**SSD 17352813– Huntingwood Processing Facility Expansion – 65
Huntingwood Drive, Huntingwood**

Blacktown Council's submission to SSD 17352813 – Huntingwood Processing Facility Expansion

**EXHIBITION OF EIS - HUNTINGWOOD PROCESSING EXPANSION - 65
HUNTINGWOOD DRIVE, HUNTINGWOOD**

SSD-17352813 Huntingwood Processing Expansion

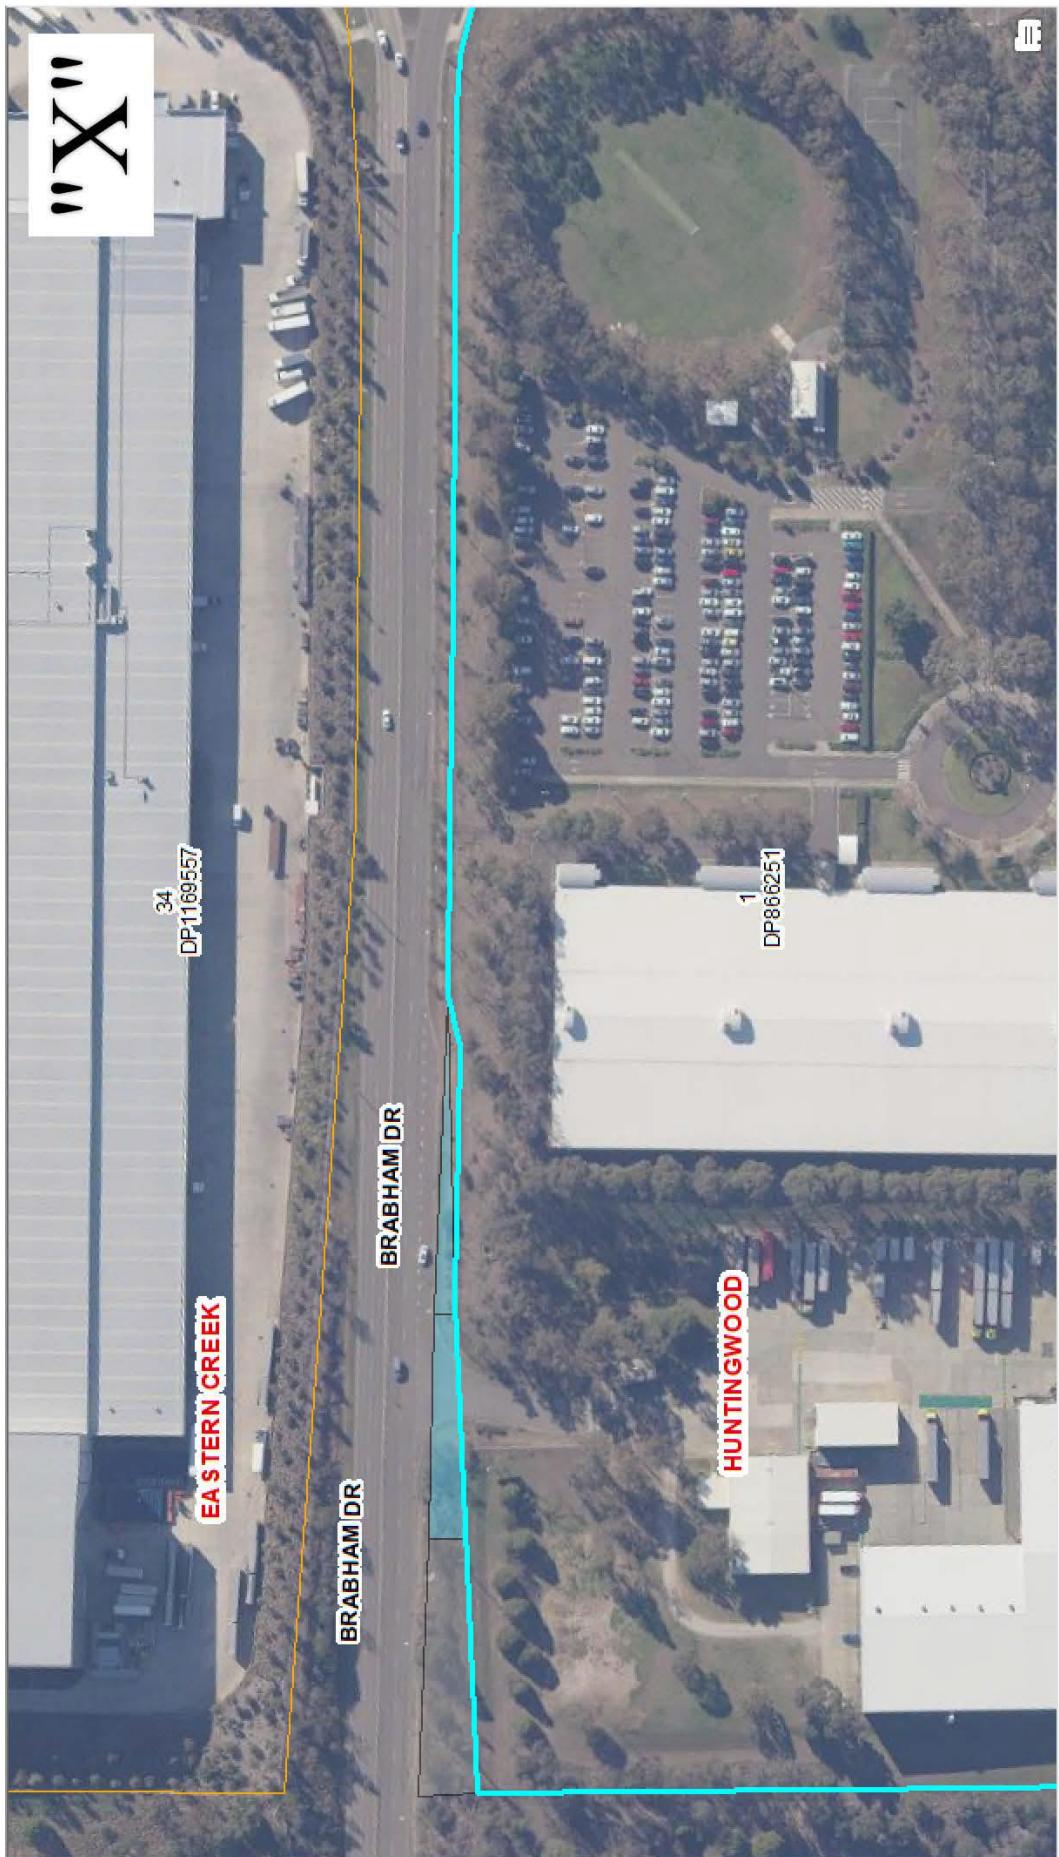
1. Transport for NSW (Roads) has previously acquired a strip of land (known as Lots 7 and 8 DP 244378) for road along the Brabham Drive frontage of the subject property, as shown by the blue colour on the attached Aerial – “X”. TfNSW has also previously resumed and dedicated a strip of land as road along the Brabham Drive frontage of the subject property, as shown by the grey colour on the attached Aerial – “X”.

The subject property also abuts a Declared Motorway (M4 Western Motorway) as shown by the blue colour and green hatching on attached Aerial – “Y”. Access is denied across this boundary.

All buildings and structures, together with any improvements integral to the future use of the site are wholly within the freehold property (unlimited in height or depth), along the M4 Western Motorway boundary
